Capital Line South LRT Extension (CLSE) What We Heard Survey Summary August & September 2017 Survey

This survey was conducted to validate the 2013 preliminary design with regards to the theme, look and feel of the corridor, and treatment of structures such as bridges. Information also requested included: a potential station at Twin Brooks, public understanding of the project, and how people currently travel within the city of Edmonton.

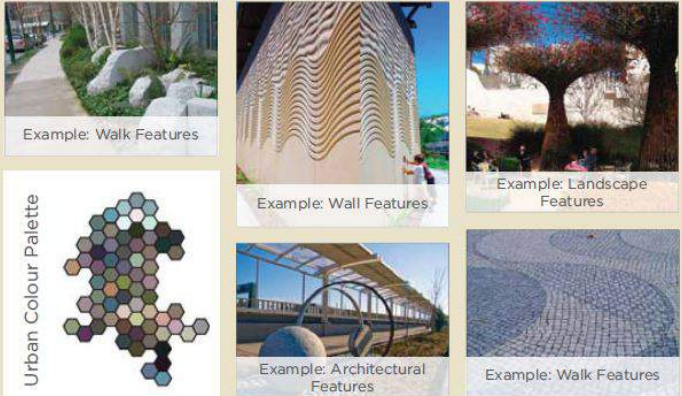
SIP Members Preferred:
**Nature Theme
Vegetation
Features:**

Along 111 Street from
9th Ave NW to
Ellerslie Road

SIP Members Preferred:
**Urban Transition
Theme Features:**

Along 111 Street to 9th Ave NW
